RS-08-110

LaSalle County Station, Units 1 and 2
Facility Operating License Nos. NPF-11 and NPF-18
NRC Docket Nos. 50-373 and 50-374

Subject: Supplemental Information Concerning License Amendment to Allow Ganged Rod Drive Capability of the Rod Control Management System

DMCPR/MCPR versus Gang Worth BOC A-sequence (10-30% power)

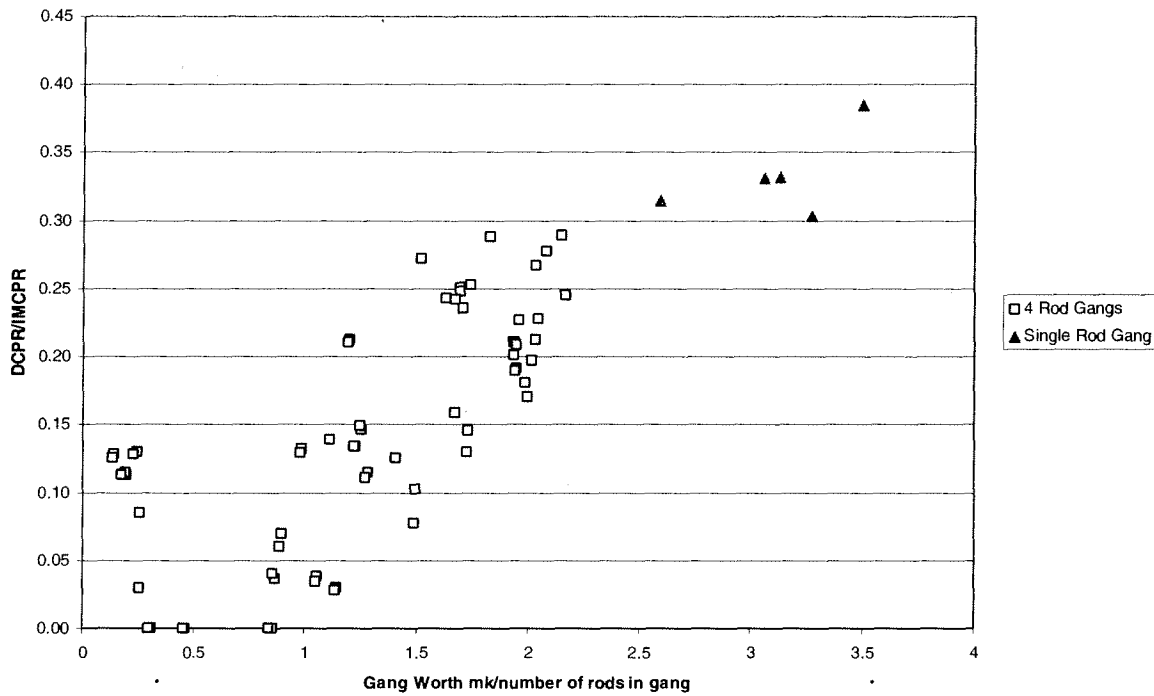
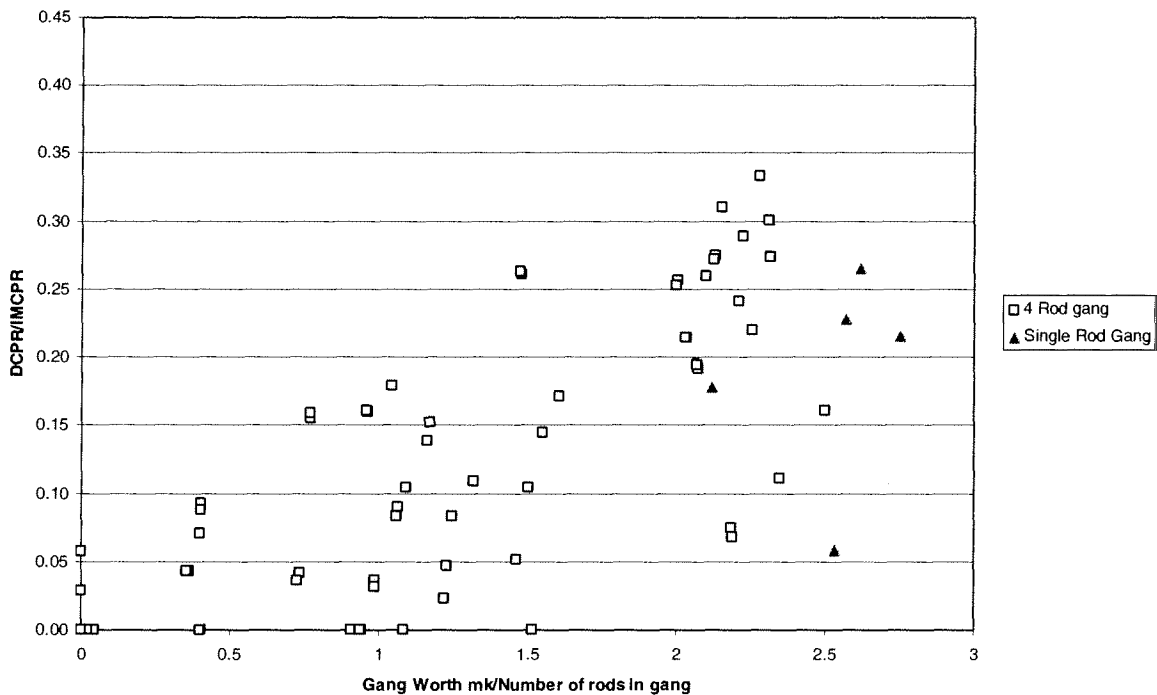
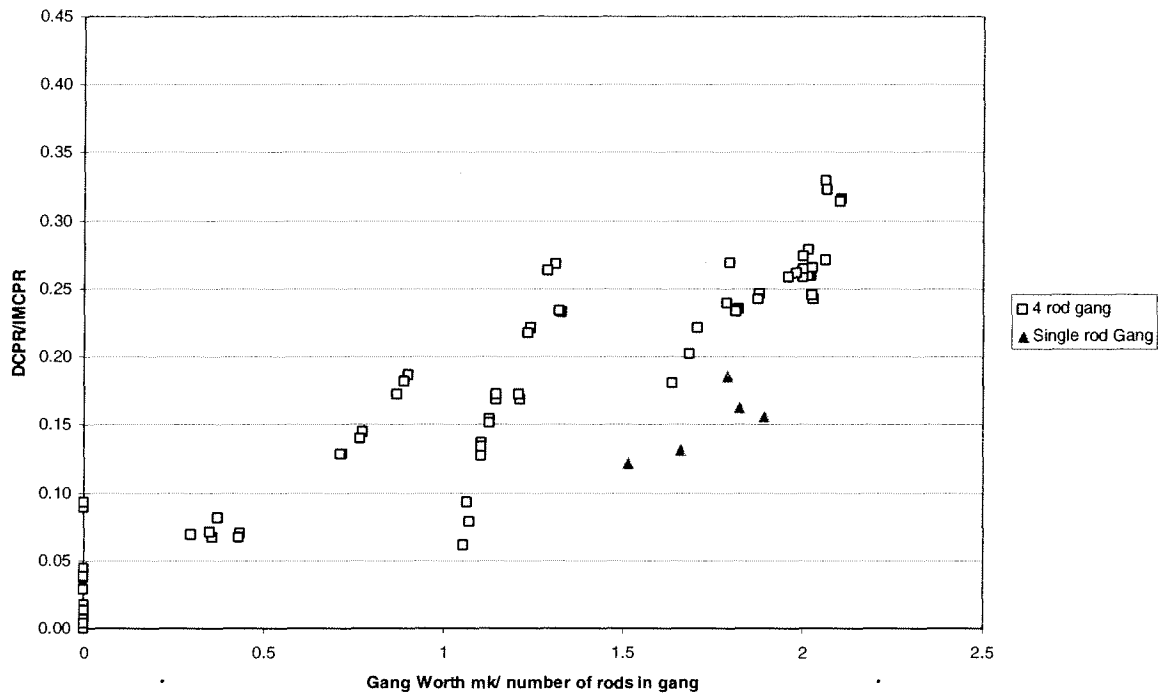
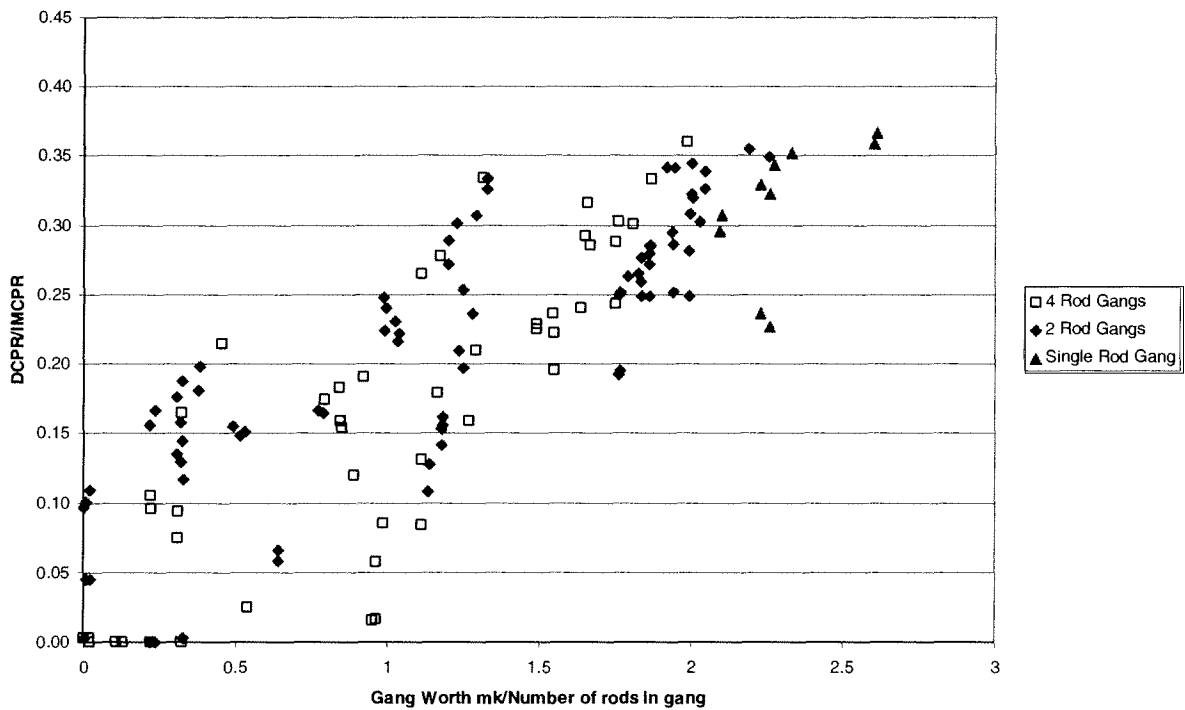
In the text of the Low Power CRWE Evaluation, it is discussed that the single rod Gang G-09A had the largest decrease MCPR, and that the same trend is demonstrated for the BOC-B sequence withdrawals in that fewer rods in a gang results in a larger change in the MCPR. Please identify the relevant nuclear and thermal-hydraulic phenomena and/or initial condition assumptions that cause this trend.

The governing phenomena are the worth of individual control rods, the fuel reactivity near the error cell(s) (i.e., the fuel cells near an erroneously withdrawn rod), and the proximity between the control rods in a gang. The approximate worth per control rod is provided in the following figures for beginning-of-cycle (BOC), peak hot excess reactivity (PHE), end-of-cycle (EOC) for the A-sequence, and BOC for the B-sequence. The ratio of DCPR to initial MCPR (IMCPR) is plotted against the worth per control rod in a gang (i.e., total gang worth in terms of mk divided by the number of rods in the gang). In this example loading, the exposed assemblies around the central cell were more reactive at BOC. As the cycle continues, the U-235 is depleted and the reactivity of the center cells decreases. Therefore, the higher worth for multiple control rods is spread out over the core and the resulting power increase in response to the reactivity insertion is spread out over the core.
